LOT 269 SITE/GRADING PLAN PATHWAYS PHASE 2

Permit Approvals - requirements at permit application	
Site Class A,B,C,D,E or F	REVIEWED By Terri Hunt at 2:44 pm, Sep 20, 2021 A, B, C, D - Standard Procedure unless dictated by other factors
Bearing Capacity Kpa	75 kPa or greater, part 9 fdtm - Standard Procedure unless dictated by other factors
Maximum Permissible Grade Raise Identified	Part 9 & 4 Foundation Requirements Geotechnical Engineer - Confirmation of part 9/4 foundation - Part 9 only - Lot specific bearing capacity values at the USF as a function of founding elevation, including footing restrictions - Part 4 only - Soil design bearing capacity, SLS and ULS at USF as a function of founding elevation, including footing restrictions - Footing sizes and the effects of long term groundwater lowering accounted for - Existing grade elevation, proposed finished grade elevation, maximum allowable grade raise, actual grade raise, proposed USF elevation - Calculated post construction settlements (include special requirements for foundation construction where calculated settlements are more than 25mm total and 20mm differential)

**GRADE RAISE REVIEW (REV. 2)
PATHWAYS AT FRIENDLY CREEK

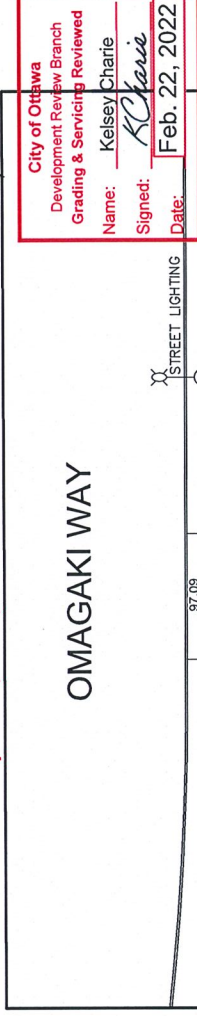
No excess drainage to be directed towards adjacent properties
Top of Foundation to be min. 0.15m above final grade
USF to have min. 1.5m cover around foundation or foundation shall be insulated

Match existing elevations with abutting properties
Grading to be 2-7%.
Grading over 7% to be terraced (max. 3H:1V)
Sleeved services required under retaining walls / footings / garage, and are recommended under porches, decks, and similar structures
